**AGENDA**  
**City of Salmon Arm**  
**Development and Planning Services**  
**Committee**

SUBJECT: Development Variance Permit Application No. VP-571 (Servicing)

Legal: Lot 2, Section 14, Township 20, Range 10, W6M, KDYD, Plan 28506  
 Civic Address: 130 – Shuswap Street SE  
 Owner/Applicant: Muto Holdings Ltd.

TO: Director of Development Services  
 DATE: 31 January 2023  
 PREPARED BY: Chris Moore, Engineering Assistant  
 SUBJECT: **VARIANCE PERMIT APPLICATION FILE NO. VP- 571**  
 OWNER: **Muto Holdings Ltd.**, 381 Highway 97B NE, Salmon Arm, BC, V1E 1X5  
 APPLICANT: **Owner**  
 LEGAL: Lot 2, Section 14, Township 20, Range 10, W6M, KDYD, Plan 28506  
 CIVIC: **130 – Shuswap Street SE**

CITY OF SALMON ARM		25m R/W Urban Arterial Road Cross-Section	
No.	Revision	Date	Date
A	ISSUED FOR APPROVAL	07/14/16	10-11-2016
			Approved  City Engineer
			SPECIFICATION DRAWING No. RD-4

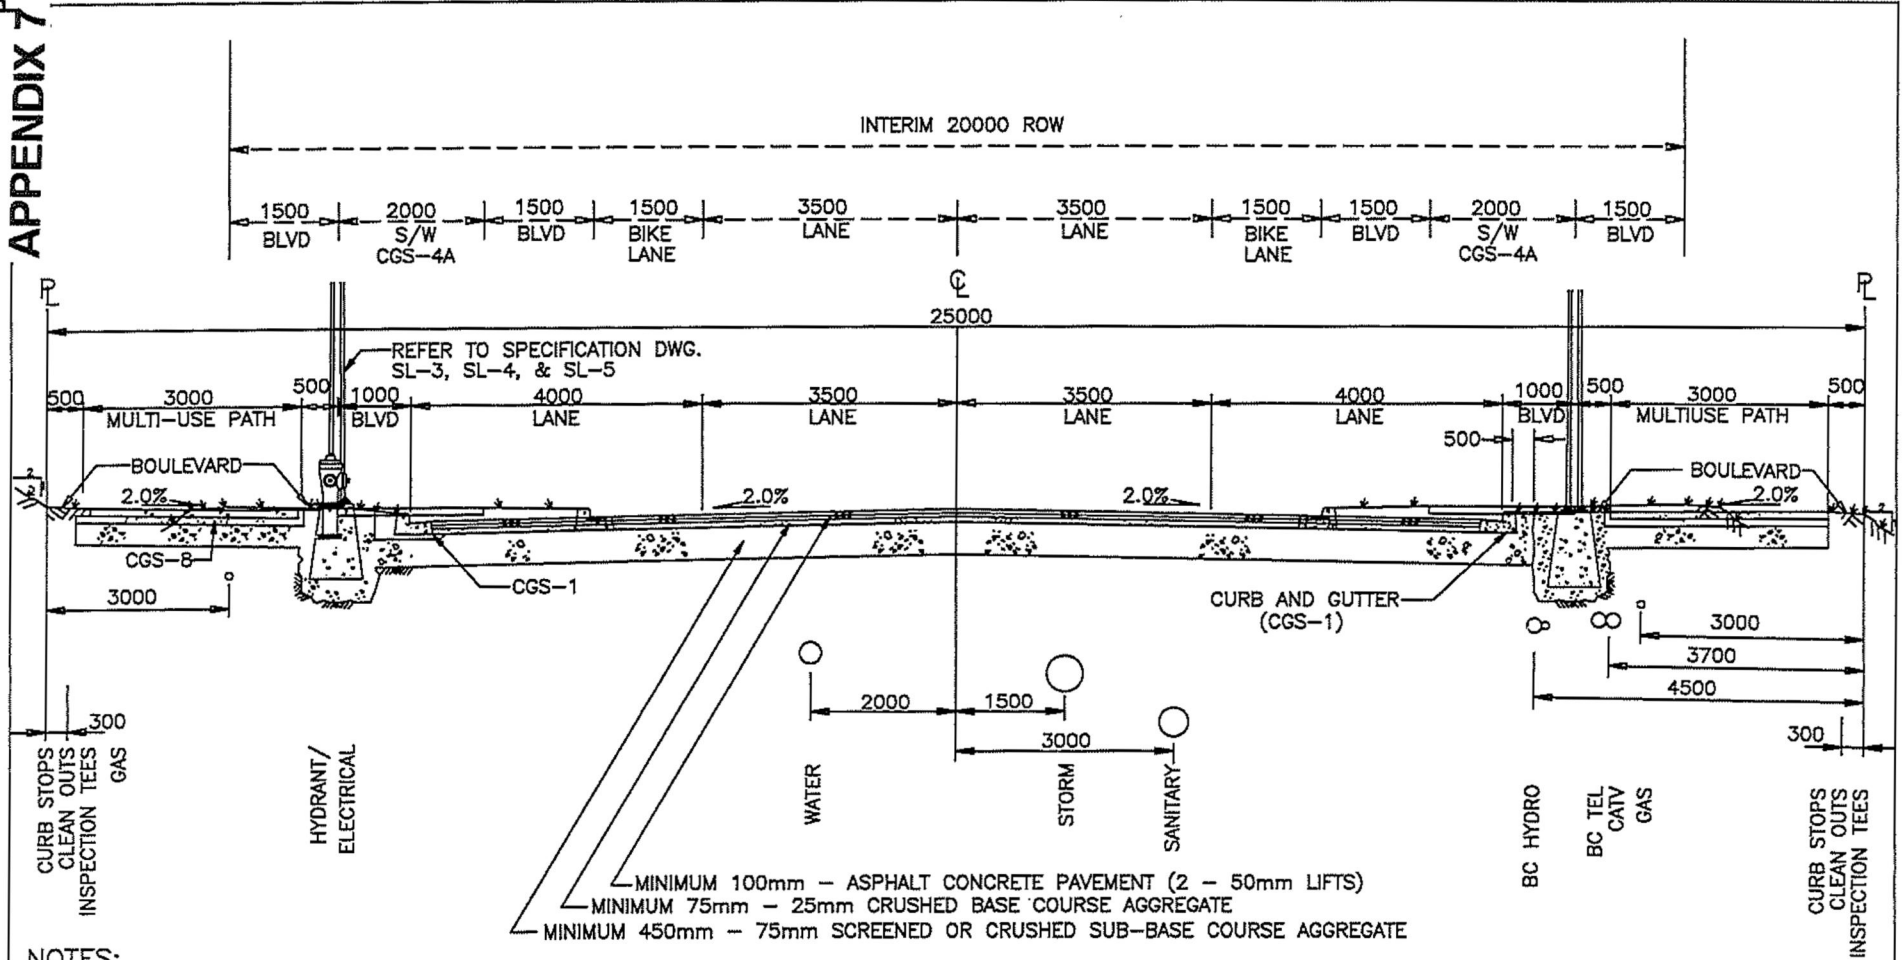
The applicants submitted a variance permit application on December 16, 2022, for the parcel at 130 Shuswap Street SE. The specification drawing no. RD-4 cross-section applicable to Shuswap Street SE further indicates the multi-use path, street lighting, and underground electrical and telecommunications wiring (Appendix 7). Site photos are attached as Appendix 8.

Shuswap Street is an Urban Arterial Road. Therefore, Hydro and Telus must be relocated underground in accordance with SDSB Table 1: Service Levels for Subdivision and Development; and the Arterial Road Cross Section (RD-4).

**APPENDIX 8**

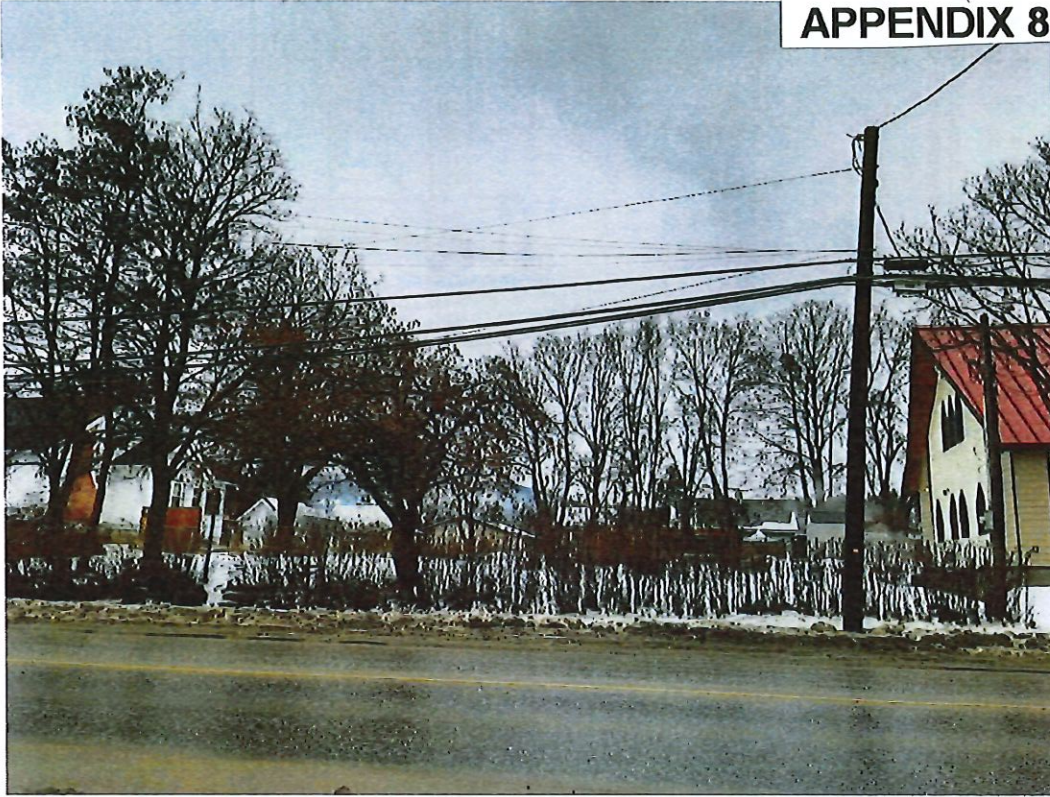
Photo 1: photo looking east at Shuswap Street SE, property frontage, and the subject property

Photo 2: photo looking south down subject property frontage and Shuswap Street SE
